APPROVED
 OFFICE OF LIEP
 CITY OF ST. PAUL

By T. Beane
 File # 08-158044 Date 10/3/08
 Any alterations from this plan must be approved by the Zoning Administrator.

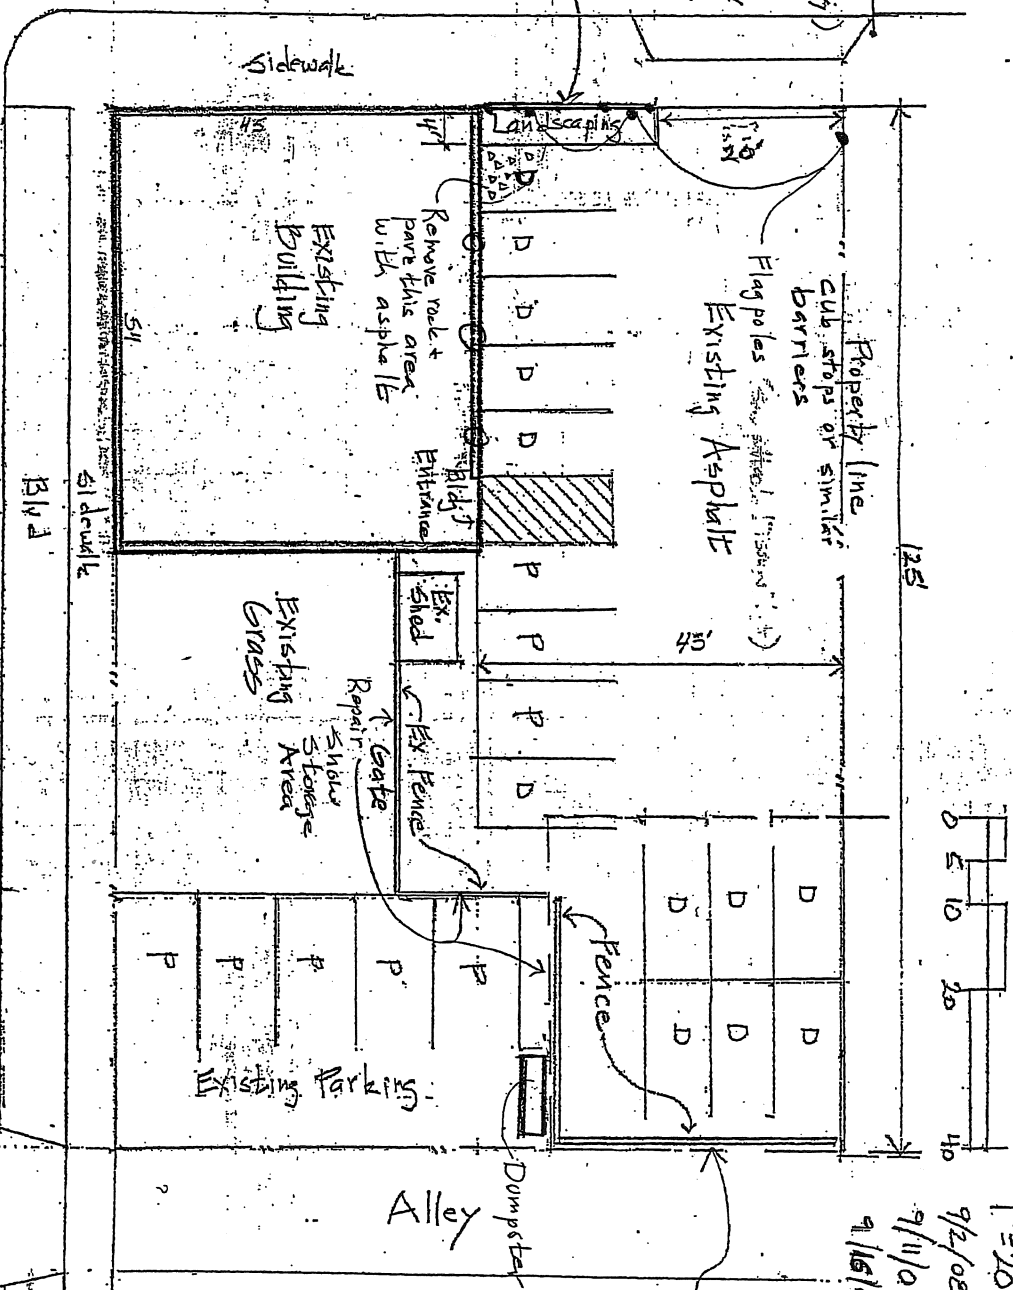
Existing Street Sign. Coroplast needs to be removed for new driveway

New Driveway Permits for PW + HNDOT required

40" high Ornamental metal fence with hedge planted behind
 Alpine Current or equivalent at 18" o/c

Replace with half of alley fence + repair south half
